**Re: Initial Submission Review – Crippen Property – Zoning Map Amendment and Master Plan**

Application Number: **DA-1435-02**

Case Numbers: **2000-2027-02; 2023-7007-00**

# Initial Submission Review

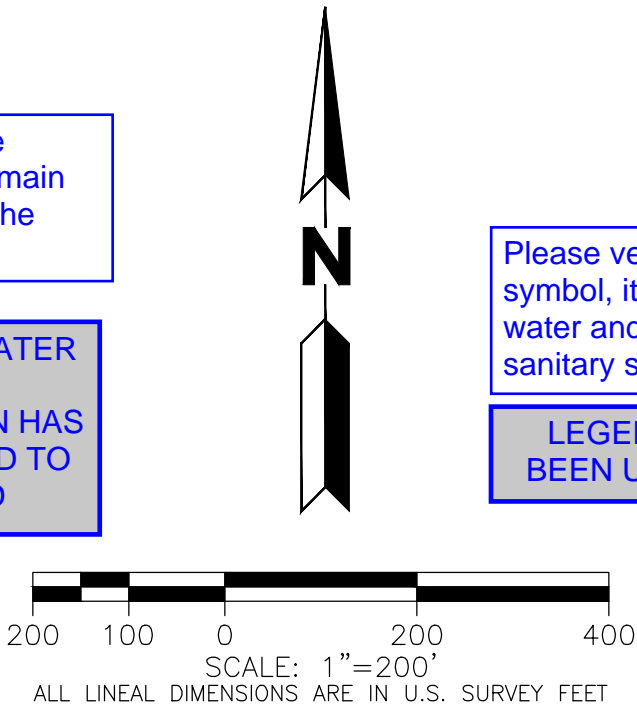
Please add the existing water main delineation to the legend.

EXISTING WATER MAIN  
DELINEATION HAS BEEN ADDED TO LEGEND
